APPLICATION NO.	FILING DATE	FIRST NAMED INVENTOR	ATTORNEY DOCKET NO.	CONFIRMATION NO.
09/484,424	01/18/2000	Satoru Bushida	VX002067	9684

Office Action Summary

DETAILED ACTION

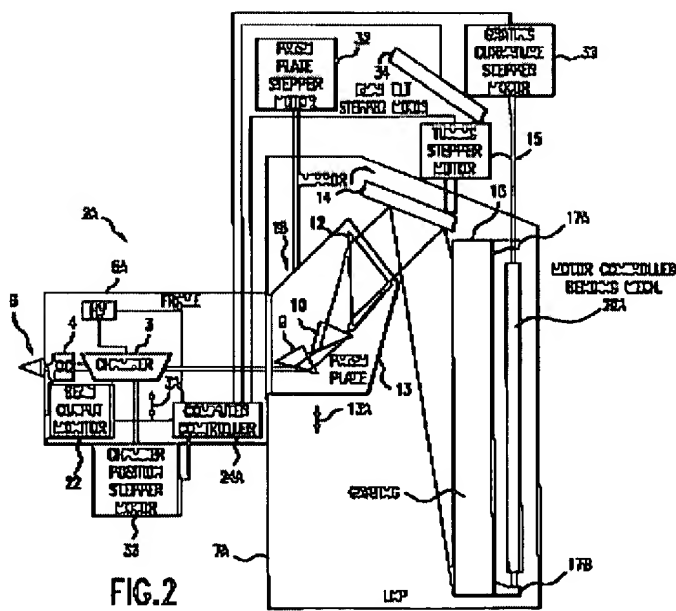
Claims 1 and 2 are rejected under 35 U.S.C. 102(e) as being anticipated by Erie et al.

Figure 2 illustrates a laser system having a grating (16) connected to a bending mechanism (20A) for providing compressive force or tension force for adjusting the curvature of the grating. The bending mechanism is connected to a grating curvature stepper motor for the controlling the grating curvature and holding the position of the grating constant, as disclosed in column 4 lines 38-45. As shown the bending mechanism and the stepper motor are separate structures where one provides the curvature bending and the other controls curvature adjustment while maintaining it at a constant position.
